Service Bulletin

Bulletin 2006-13-ABDE**Page 1 of 1****Date: 08/18/06**

SUBJECT: Performance Pro and Master Jet Target Replacement

Ceramic Deflectors

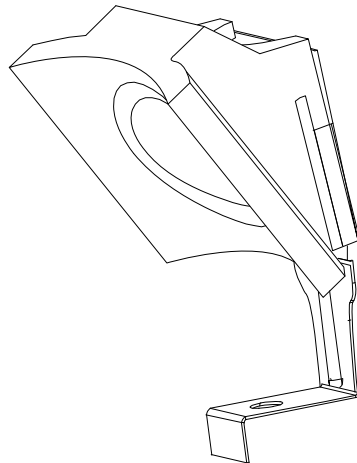
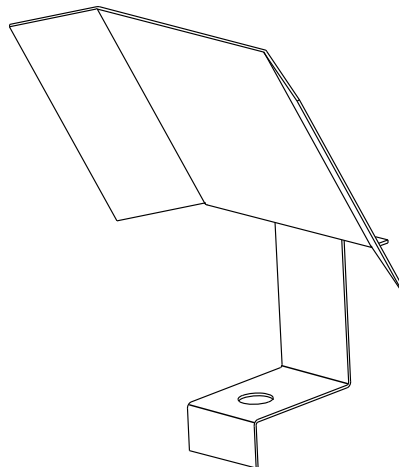
Effective August 2006, ceramic deflectors and the brackets that hold them will be replaced with one-piece metal deflectors for Performance Pro and Master Jet fryers. This is a direct replacement. If the ceramic target and bracket are ordered, you will receive a one-piece metal target. Ceramic targets (without brackets) will be available until supplies are exhausted. Ceramic and metal targets can be intermingled in the same fryer.

230-1177 replaces 806-0225 (45 & CF, side)

230-1206 replaces 806-3606 (45, rear)

230-1178 replaces 806-4720 (35, side)

230-1180 replaces 806-3605 (35 & CF, rear)

230-1568 **MUST** be used on all J1Cs and MJ15s for proper operation and light-offs.
